VEHICLERECALL

SC288

Date: 1/25/05 (Supersedes SC288 dated 10/14/04)

Subject: Steering Gear Mounting Bolt Torque — CX and CH Model Chassis

Figure 2 — Steering Gear Mounting Arrangement — CX and CH Models

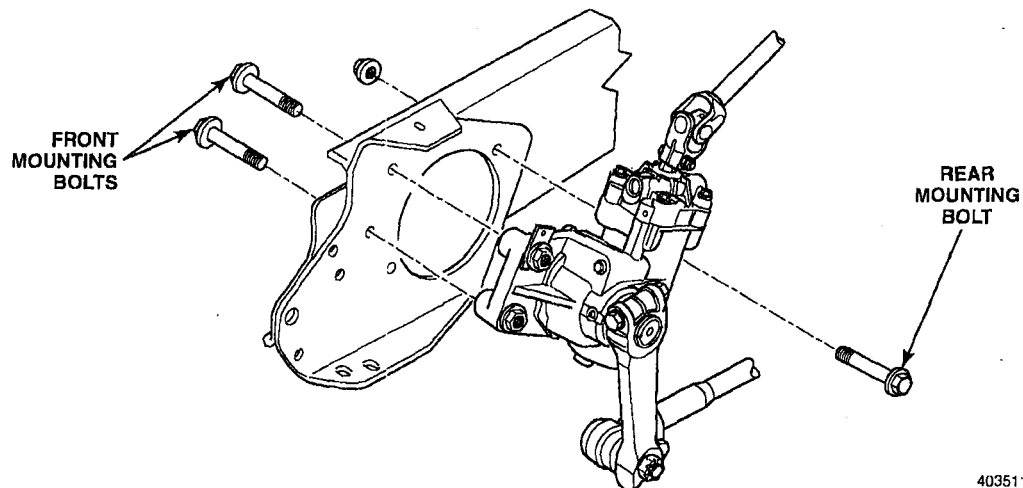
On CX and CH models, the two front steering gear mounting bolts are installed from inside of the frame rail. On CX models, clearance between the frame rail and the charge air cooler is not sufficient to allow removal of the two front bolts, making it necessary to move the steering gear away from the frame rail to cut the mounting bolts as close to the frame as possible. On CH models, however, replacing the steering gear mounting bolts is simply a matter of removing each bolt, one at a time, and replacing with new bolts, nuts and hardened flat washers. On both CX and CH models, the replacement bolts are to be installed from the outside of the steering gear. The procedures outlined below that cover moving the steering gear away from the frame rail and cutting the mounting bolts, apply to CX model chassis only.

The three steering gear mounting bolts on all affected chassis must be replaced.

Figure 3 — Preparing to Cut Mounting Bolts — CX Models

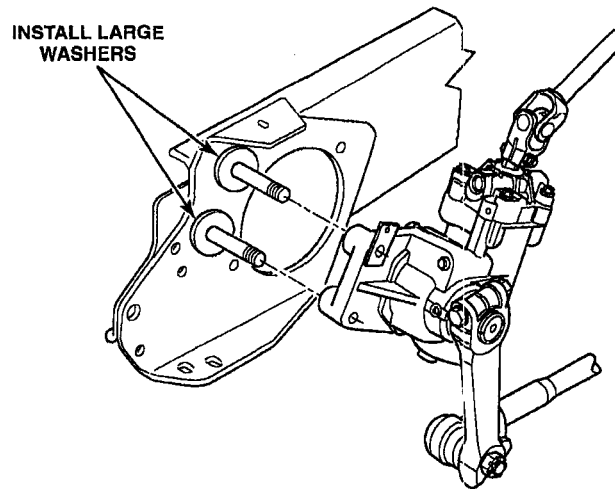
4. Remove the nuts from the three steering gear mounting bolts, and then remove the rear mounting bolt from the steering gear.
5. With the hoses and linkages (input shaft and drag link) still attached, pull the steering gear away from the frame rail far enough to clear the two mounting bolts remaining in the frame.
6. Install a large washer (having an inside diameter of at least 5 1/64") over each of the two bolts. These washers will help protect the frame rail from damage as the bolts are being cut with the torch.
